Motorcycle/ATV Division

VS/VX/VZ/VL No. 091

June 26, 2015

SAFETY RECALL CAMPAIGN VZR1800 Backrest Mounting Bolts

Incorrect mounting bolt

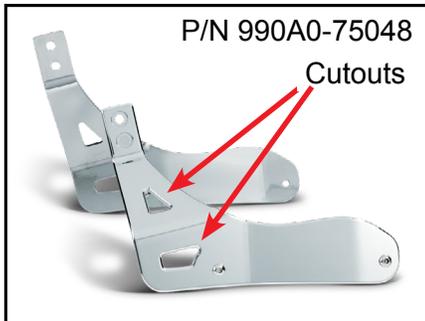
The mounting hardware for installing the Suzuki Genuine Accessory backrest P/N 990A0-75148 and P/N 990A0-75148-BLK on 2006 - 2015 Suzuki VZR1800 (Boulevard M109R) motorcycles may contain 110mm mounting bolts, which is an incorrect length. Under certain loads and riding conditions, it may be possible for the mounting bolts to contact the rear tire, damaging it and/or causing loss of control.

Late Model Bracket without saddlebag supports
NEEDS REPAIR
Because it is equipped with incorrect four 110mm mounting bolts — these bolts must be replaced with correct 75mm (two) and 95mm (two) mounting bolts.

VZR1800 backrest mounting bolt replacement procedure:

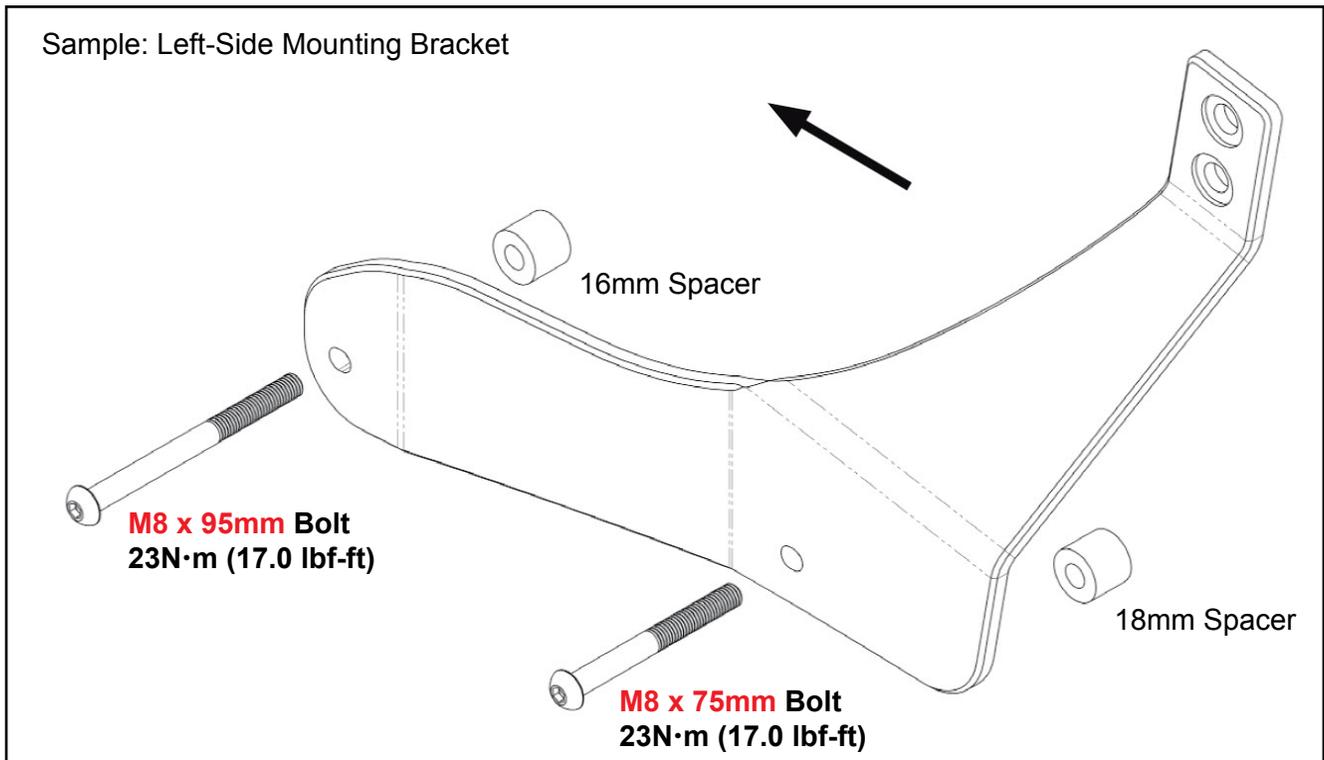
Before replacing the mounting bolts, inspect the rear tire for possible damage from the 110mm bolts. If the rear tire or other parts are damaged, contact your TSM for prior authorization for tire replacement.

- 1) Use a 5mm hex bit to remove the two left-side rear fender strut mounting bolts. The rear bolt has a separate nut on the inside of the fender — use a 12mm wrench to remove it.
- 2) Verify that the 16mm spacer at the front of the bracket and the 18mm spacer at the back of the bracket are correctly positioned between the bracket and the fender strut mounting holes. **See the illustration below.**
- 3) Insert one front-mount **M8 x 95mm** socket button-head bolt and one rear-mount **M8 x 75mm** socket button-head bolt, then use 5mm hex bit to secure the backrest mounting bracket to the fender strut.

Do NOT fully tighten the button-head bolts at this time.

- 4) Repeat steps 1 - 3 for the right side.
- 5) Torque the left and right backrest bracket mounting bolts.

Backrest Bracket Mounting Bolt Tightening Torque: 23N·m (17.0 lbf-ft)

- 6) Inspect the inner fender clearance between the bolts and the rear tire. The bolts must NOT extend so that they can contact the tire during vehicle operation.

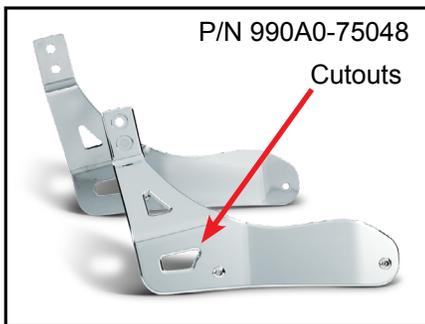
The mounting hardware for installing the Suzuki Genuine Accessory backrest P/N 990A0-75148 and P/N 990A0-75148-BLK on 2006 - 2015 Suzuki VZR1800 (Boulevard M109R) motorcycles may contain 110mm mounting bolts, which is an incorrect length. Under certain loads and riding conditions, it may be possible for the mounting bolts to contact the rear tire, damaging it and/or causing loss of control.

If the backrest mounting bolts come into contact with the rear tire, the rider could lose control, increasing the risk of a crash.

Late Model Bracket
without saddlebag supports
NEEDS REPAIR
Because it is equipped with incorrect four 110mm mounting bolts — these bolts must be replaced with correct 75mm (two) and 95mm (two) mounting bolts.
